CONSUMERS POWER COMPANY

Docket No 50-155

Request for Change to the Technical Specifications

License No DPR-6

FIGURE 6.2-1
10-2

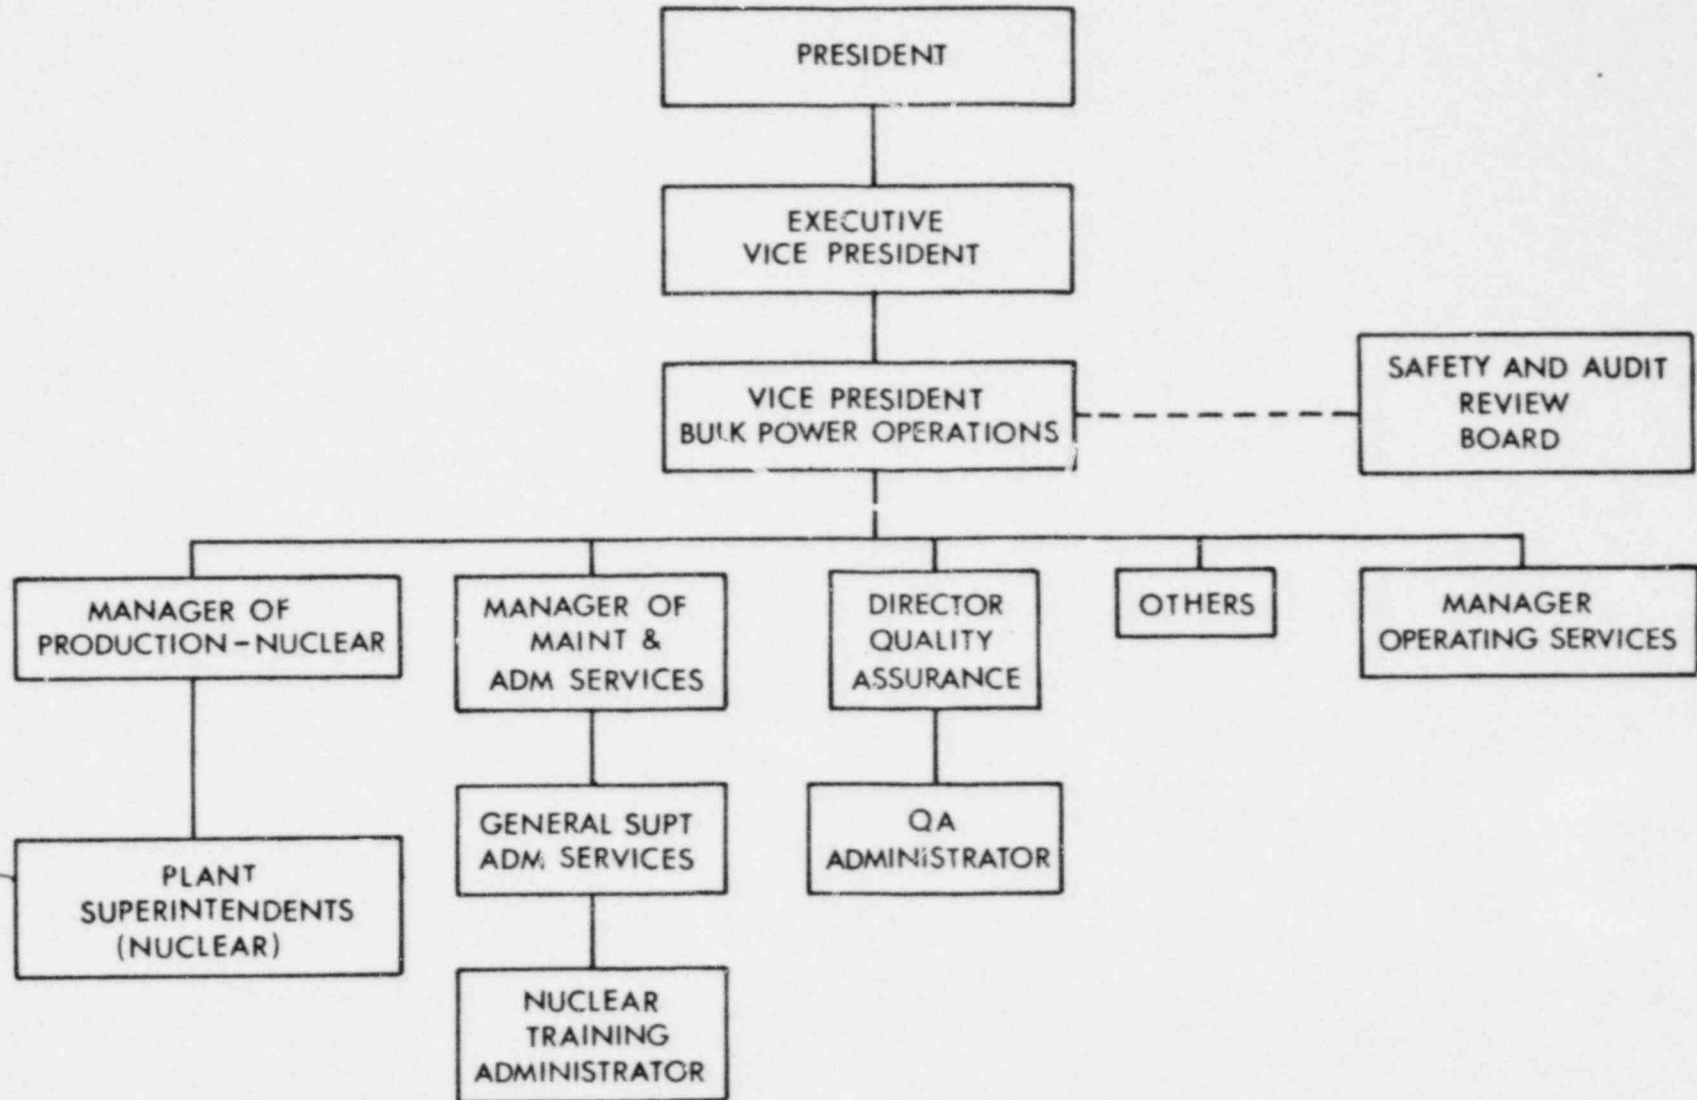
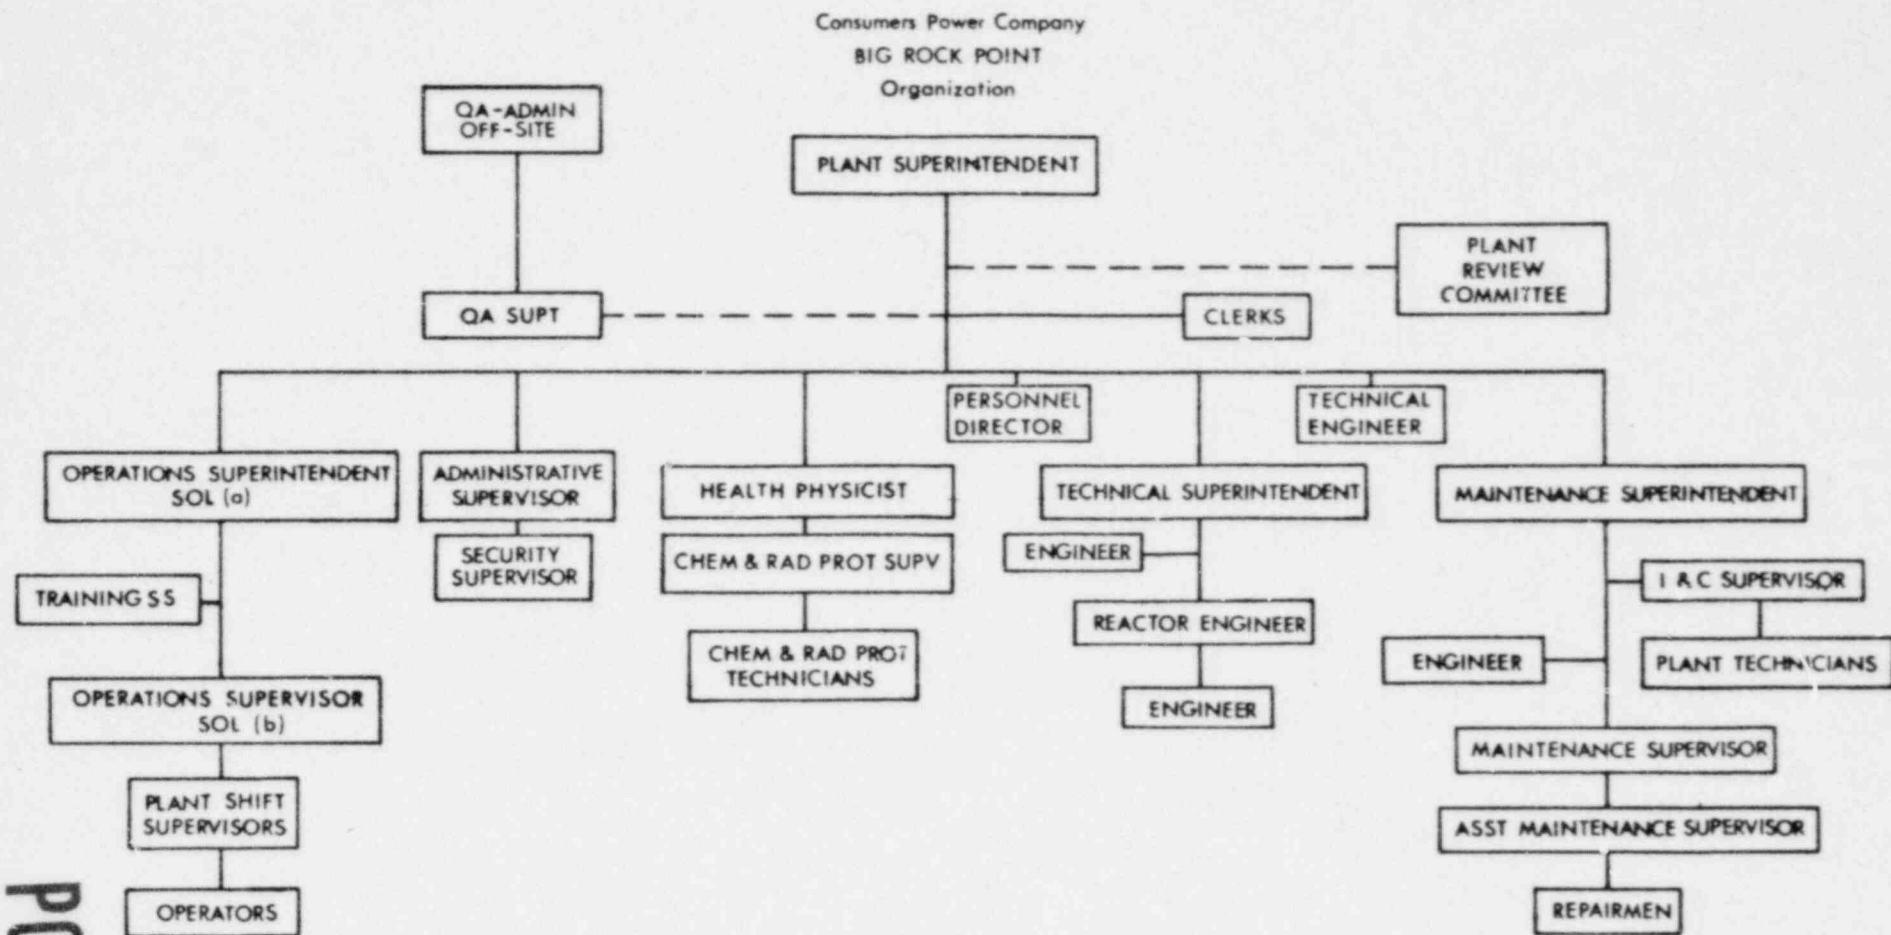
B. Remove Page 10-2, "Figure 6.2.1, Consumers Power Company Off-Site Organization," and replace it with the following:

At the time of the issuance of the December 19, 1975 Administrative Control Technical Specifications, the Consumers Power Company organization contained a Vice President - Bulk Power Operations and an Executive Manager - Bulk Power Operations. On January 1, 1976 Mr R. A. Lamley retired from Consumers Power Company. Mr C. R. Bilby, formerly Executive Manager - Bulk Power Operations, was appointed to Vice President - Bulk Power Operations to replace Mr Lamley. At present, Consumers Power Company does not plan to fill the slot vacated by Mr Bilby. Thus, Figure 6.2-1 and Pages 10-7, 10-8, 10-10 and 10-11 have been appropriately revised to reflect this organization change.
